Request for Class II Permissive Change

FCC ID: BEJE2442TA **Data: Jul 30, 2012**

Please be notified that we, the undersigned, LG Electronics U.S.A., Inc. declare that the reasons for this Class II permissive change are as below:

1. To change the main IC

PCB and block compare

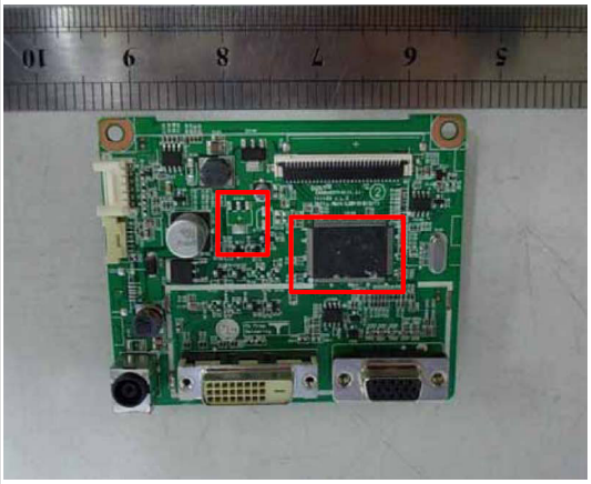
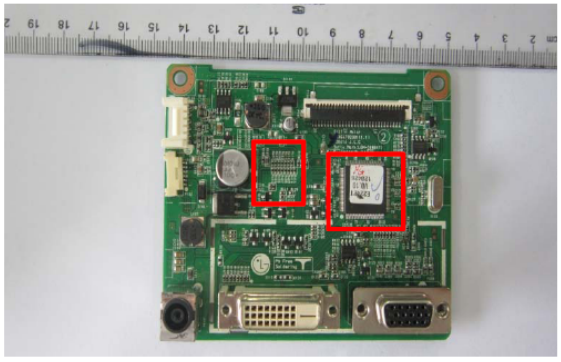
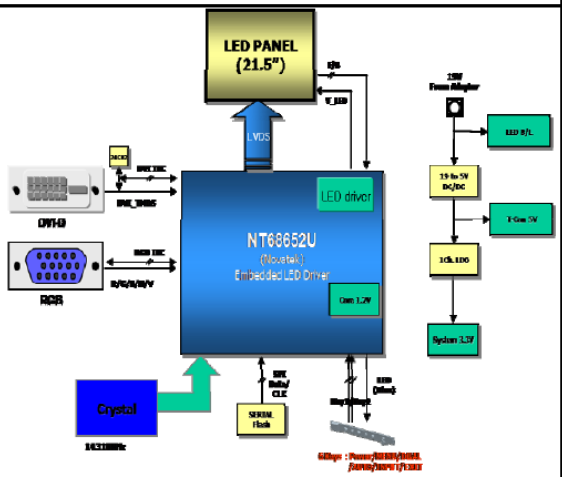
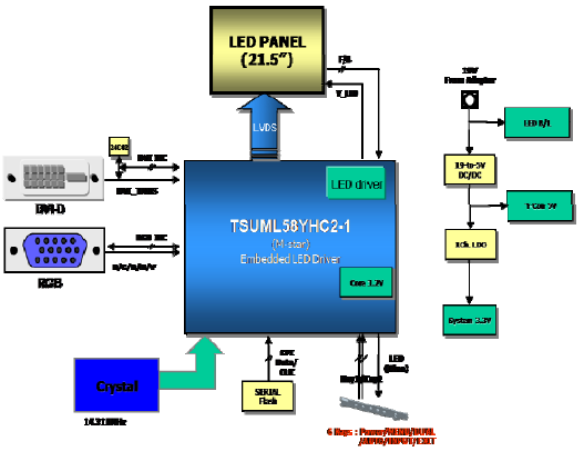
Different: 1. Main IC circuit 2. LED drive
Block

Maker	old	new	Change
Main IC circuit

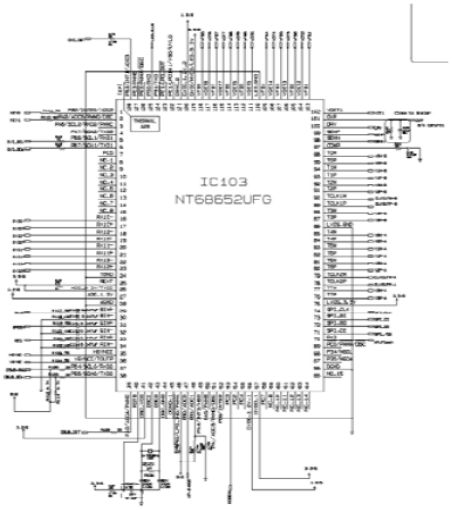
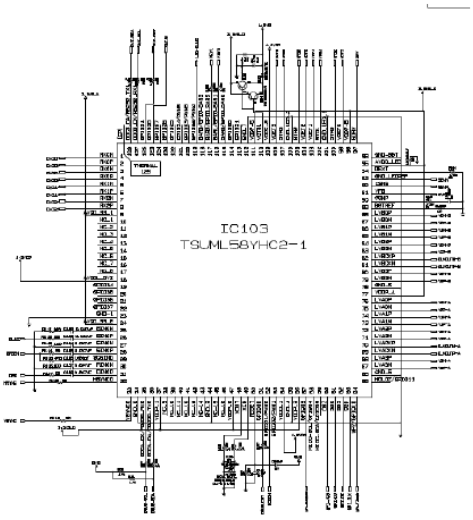
**1) Size: different** **2) Pin No.: Same** **3) Pin output: change** **4) Maker different**
LVDS out

Maker	old	new	Change
LED drive CH

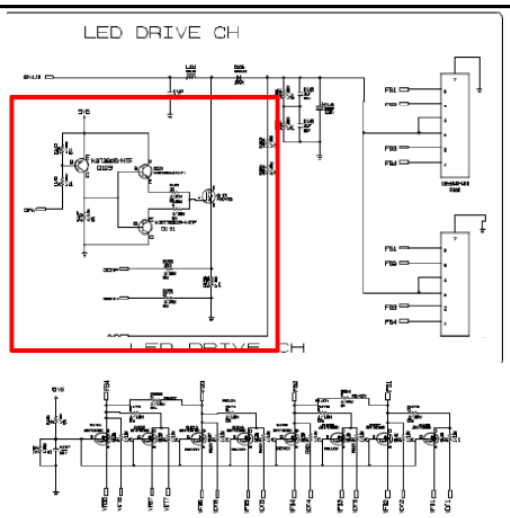
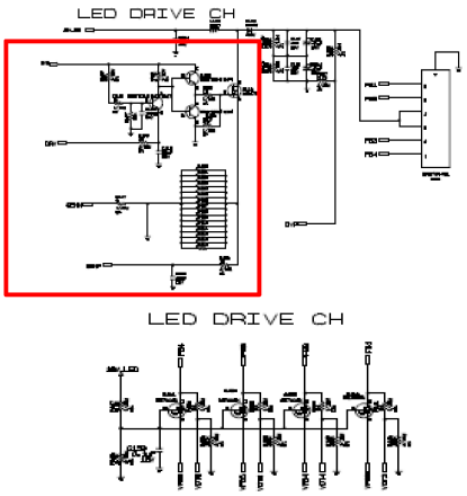
**Change :** **Mos transistor** **→resistor** **Reason: cost down**
19V to 5V
